FL804AB

REVISED NOTICE

## Subject: TBB Saf-T-Liner C2 Power Ports

**REVISIONS:** In the *Auxiliary Port and PV360 Harness and Label Installation* procedure, see updated steps 7, 8, and 12.5. Please review.

**Figure 6: Location of Positions E, G, J, and L**

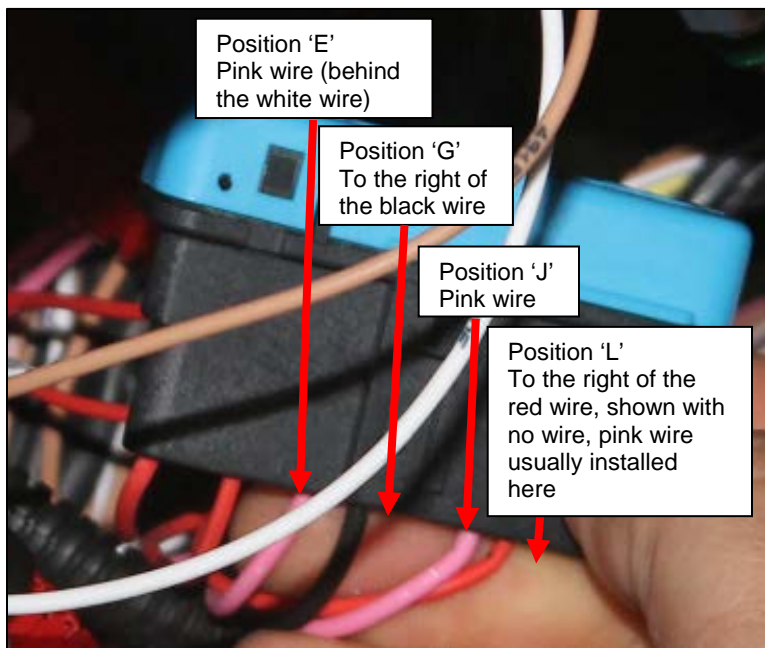
7. Push the terminal of wire 52B\_2 (from new harness TBB 221296) into Position 'G' until it locks into place.
8. Cut the wire in Position 'J' and put a cap or sealing butt splice on the wire coming out of the plug. See **Figure 6** for location of Position 'J.'
9. Take the remaining wire cut off from plug Position 'J' and connect it to 52D\_1 from harness TBB 221296.
10. Push wire 52D\_2 into the terminal at Position 'L' until it locks into place. See **Figure 7**.
11. Reinstall the gray wire "keeper" on the back side of the plug. See **Figure 8** for final installation.

**Figure 9: Battery Wire Installation**

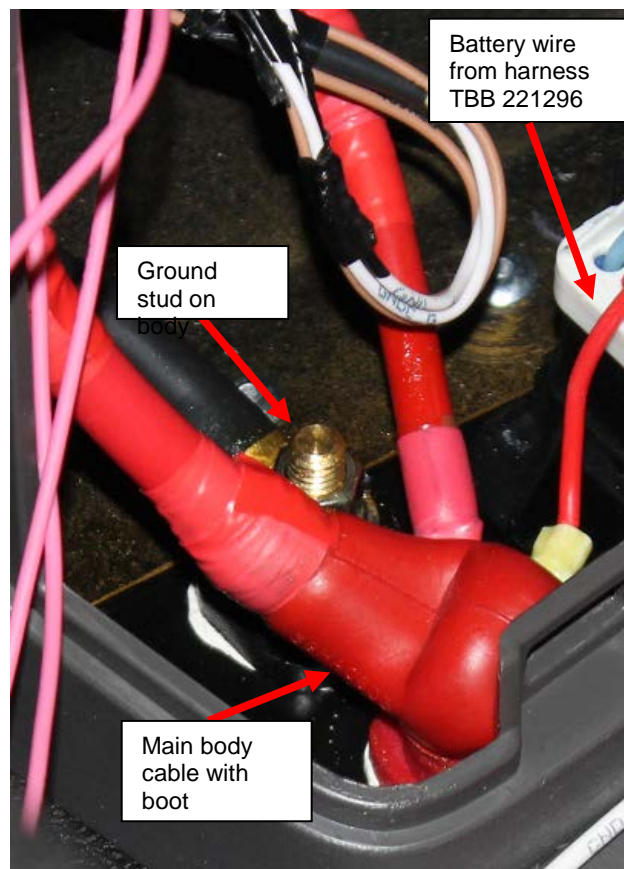
- 12.4 Attach the red wire with the ring terminal from harness TBB 221296 to the battery cable connection. Reinstall cables previously removed.
- 12.5 Tighten the nuts on the battery ground cables 140-150 lbf-in.
- 12.6 Pull the boot back over the battery cable. See **Figure 9** for final power cable installation.
